Mallinckrodt

March 24, 2006

RE: NRC Docket 40-06563, NRC License STB - 401

Mallinckrodt's responses to certain NRC staff requests for information concerning the Draft C-T Phase II Decommissioning Plan (CT Phase II DP) are enclosed. These responses are a follow-up to discussions between Mallinckrodt and NRC staff on January 24, 2006. This meeting was summarized in the NRC report, dated February 16, 2006, and these responses relate specifically to Actions 2, 4, and 5. Enclosed are five copies of the following:

Figure 41. Maximum Annual Radiological Dose Versus Source Depth in Soil
(infinitely-thick source ratio 3 U series + 1 Th series produces 25 mrem/yr)

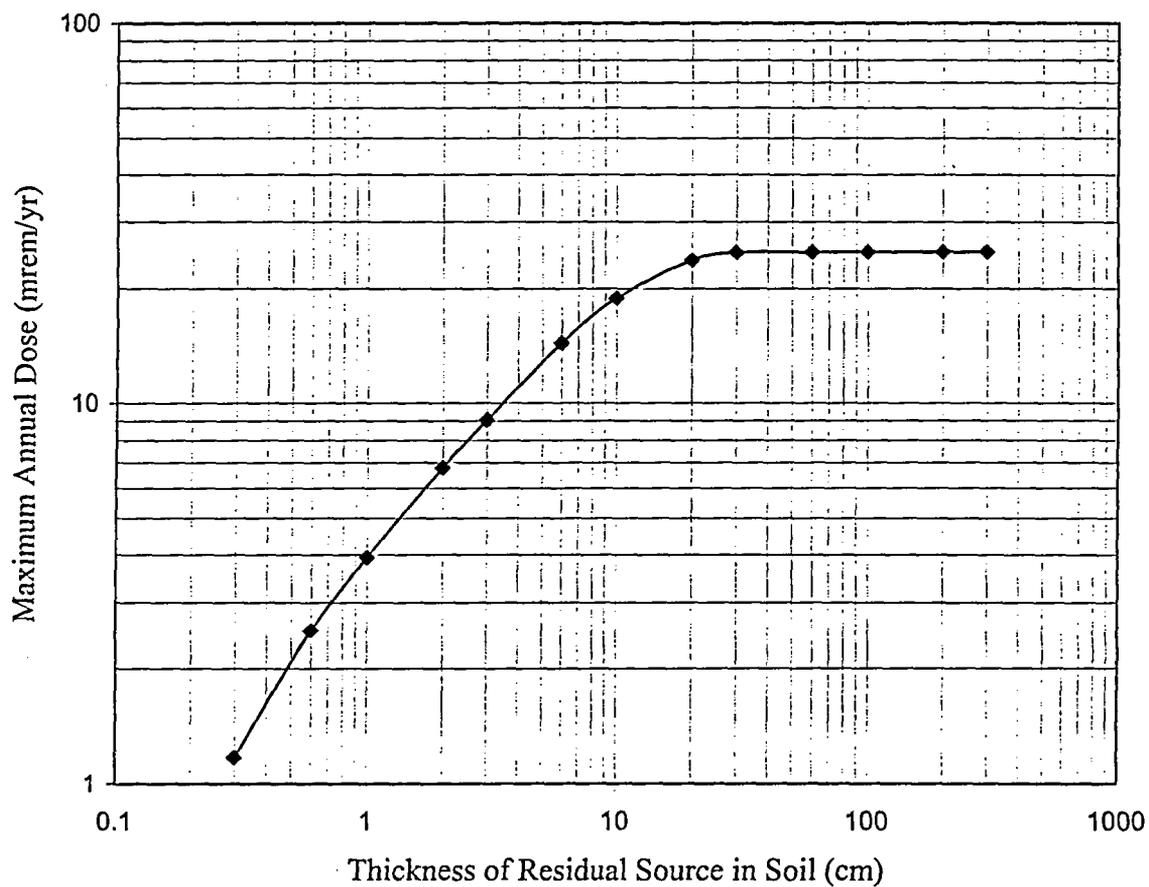
As noted in the NRC report of a meeting¹ between Mallinckrodt and NRC staff concerning radiological dose modeling pertaining to C-T Phase II Decommissioning, the NRC staff wants additional clarification in response to certain of its Requests for Additional Information. It also wants additional clarification of plans for final status survey of pavement and of soil beneath pavement. These interests are addressed in the following text.

The result of this analysis is summarized graphically in Figure 41. It determined that, in representative simulation, maximum dose rate by direct irradiation is reached asymptotically as the depth of the contaminated zone in topsoil reaches about 30 cm. Additional source thickness would not produce significantly greater dose rate.

This evaluation of the merit of our original modeling representing source thickness has demonstrated that the original basis of 2 meters source depth was exceedingly conservative in modeling dose and deriving DCGL. Nevertheless, we will represent the thickness of contaminated zone parameter as a variable in probabilistic modeling. It is being represented as a uniform distribution ranging from 0 to 1 meter thick. It is being represented as a uniform distribution because characterization survey soil sampling intervals are insufficient to resolve a well-defined gradient within this range. A maximum depth of 1 meter is more than sufficient to be a conservative representation insofar as direct irradiation is concerned.

Figure 43A. Cumulative Distribution of Indoor and Outdoor Shielding Fraction

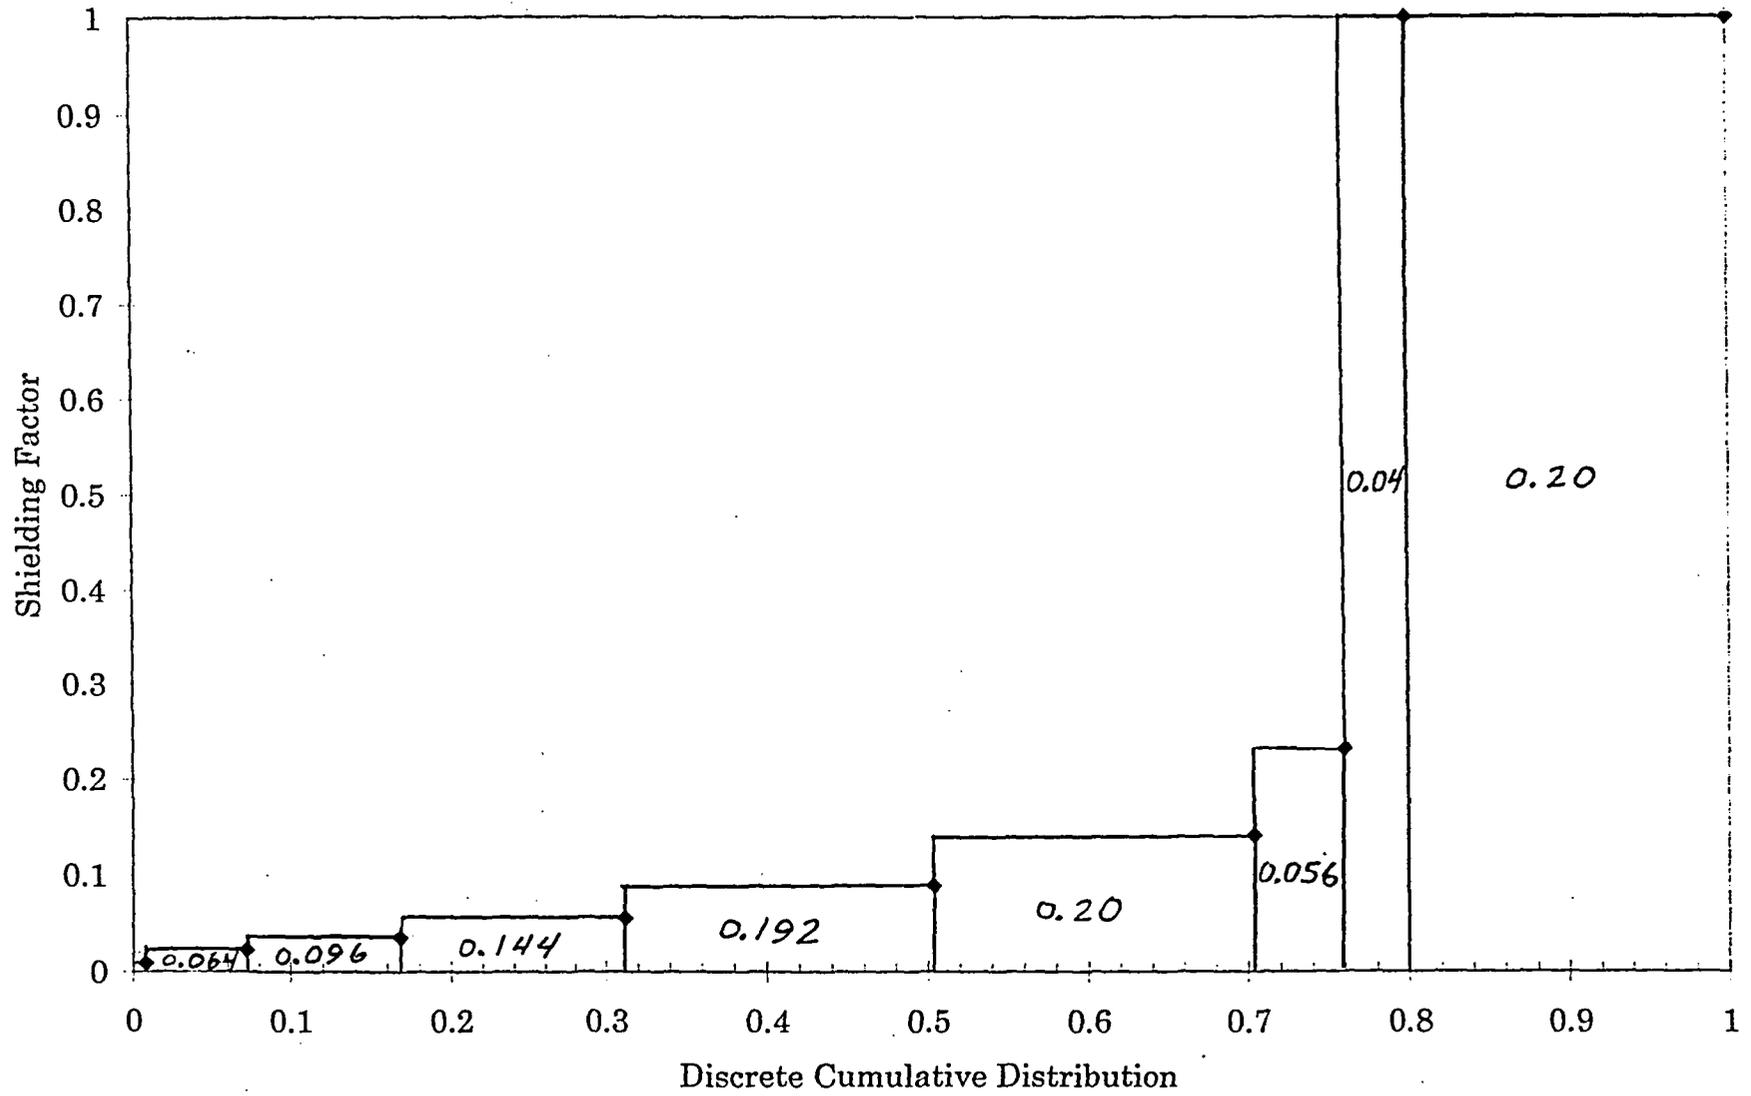
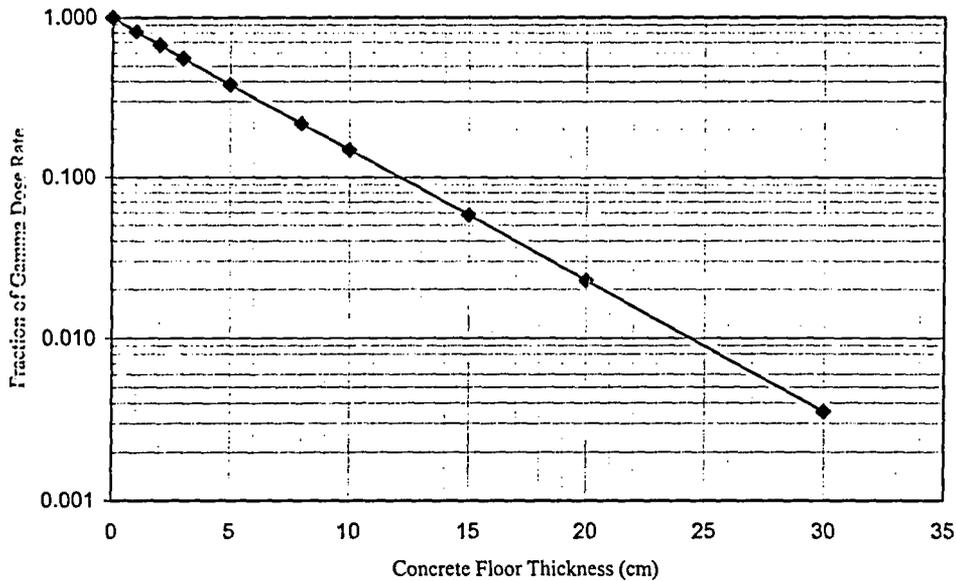
(c) The licensee selected an indoor gamma shielding factor of 0.17. In other words the licensee assumed that only 17% of outdoor gamma radiation can be penetrated indoors. The RESRAD default value is 0.7. The licensee indicated that Plant 5 has concrete slab floors or concrete walls with few windows. Therefore, the licensee assumed that the factor 0.17

DCGL have been revised to include the effect of probabilistic distribution of indoor gamma shielding factor.

An analysis of the effect of radiation attenuation by a building, especially floor thickness, on radiological dose for the portion of time a worker spends indoors during industrial occupation has been performed. Occupancy 20% of the time on bare ground, with gamma shielding factor = 1.0, is, in addition, assumed to apply deterministically while out-of-doors, even though most of Plant 5 is paved. Overall, then, dose modeling has been adjusted to simulate a person on bare ground about 24% of their time while on-site and thin shielding; an additional 5.6% of the time. This is illustrated diagrammatically in Figure 43 A. (same as CT 2 DP Appendix C, Attachment A, Figure C3.)

The gamma shielding factor indoors has been revised to treat it probabilistically and to assume a fractional occurrence on bare ground and a thin floor. Table 43-1 (same as CT 2DP Table 5-2) describes the discrete cumulative probability distribution simulating the external gamma shielding factor that is applicable indoors.

Figure 48 Refinement of CT 2 DP §5 Model for Pavement

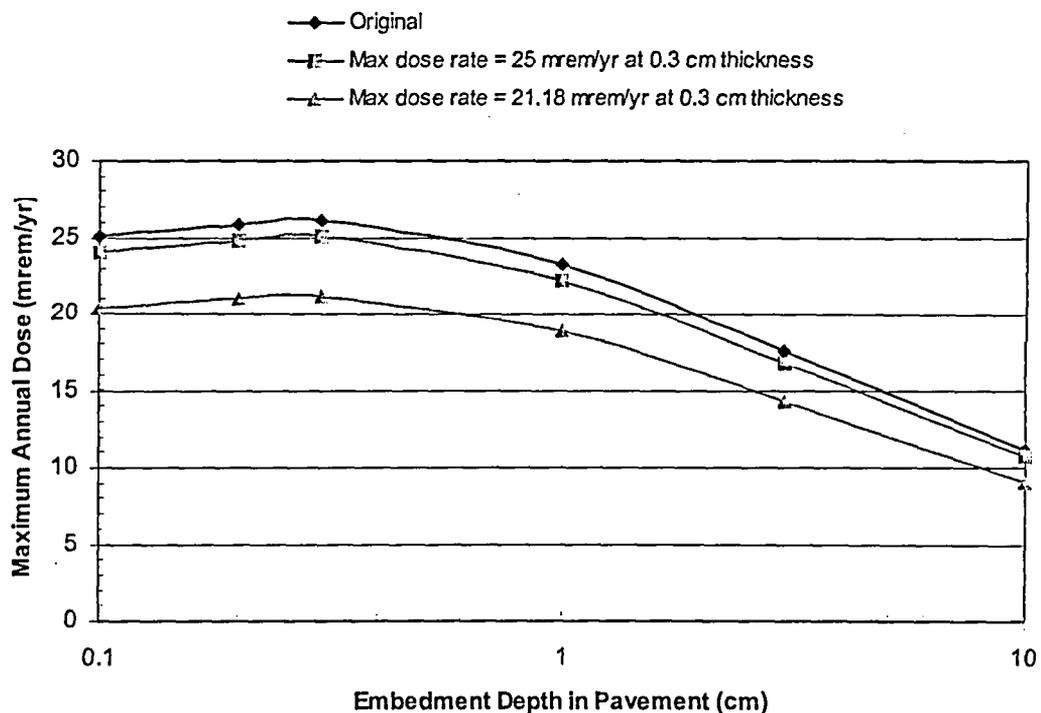
(h) Assumptions for the Industrial Worker Exposure to Pavement: For the exposure of industrial worker to residual radioactivity on pavements, the licensee made similar assumptions as those for the soil. However, the licensee assumed a thin layer of surface contamination on pavement with thickness of 0.1 cm. The licensee modified the approach to convert volumetric dose analysis results into surface activity results (e.g., dpm/100 cm²). This was done through derivation of the radionuclide volumetric dose factor (mrem/y per pCi/g), converting this factor into areal density factor pCi/100 cm² (e.g., by assuming a thickness of pavement of 0.1 cm and a density of 1.5 g/cm³) corresponding to 25 mrem/y and then converting the pCi into dpm (e.g., by multiplying by 2.22). Therefore, considering the volumetric dose analysis approach the following parameters and assumptions were made for industrial worker exposure to the pavement source: (i) Contaminated Zone: the

The licensee needs to verify that contamination only exist in a pavement medium of 0.1 cm thickness and no contamination below this thin crust of the pavement. In addition, by assuming an erosion rate of zero the licensee assumed that the pavement would be maintained through a performance period of 1000 years. The licensee needs to verify these assumptions and provide data and a rationale that the thin pavement layer would be maintained over a 1000 year time-frame.

A premise of CT 2 DP, §5, Table 5-3 is that an equivalent areal density of CT residue would produce less dose when embedded than when accumulated on the surface; hence the source was originally modeled as concentrated into a 0.1 cm layer on the surface. Unexpectedly, maximum total dose occurs when the source is 0.2 to 0.3 cm thick, or deep, as illustrated in Figure 48, curve “♦ Original.”

This observation prompted derivation of DCGL_w assuming 0.3 cm contaminant thickness of the long-lived radionuclides in the uranium series, the actinium (U²³⁵) series, and the thorium series, assuming short-lived nuclides (<180 day half-life) to be in transient radioactive equilibrium with their parent. The revised result appears here in Table 48-1. The result of this refinement is illustrated in Figure 48 by the curve, “■ Max. Dose Rate = 25 mrem/yr at 0.3 cm thickness”. Thus, if contamination were on the surface or even if it were unevenly embedded into pavement or a building slab, controlling to a maximum areal density specified in Table 48-1 would assure that maximum annual dose would not exceed 25 mrem/yr.

Figure 48, curve “▲ Max dose rate = 21.18 mrem/yr at 0.3 cm thickness,” confirms that the revised DCGL_w in Table 48-2, to become CT 2 DP §5, Table 5-4 (replacing Table 5-3),¹¹ would constrain maximum potential annual dose from contamination on pavement, even if embedded, to no more than 21.2 mrem/yr.
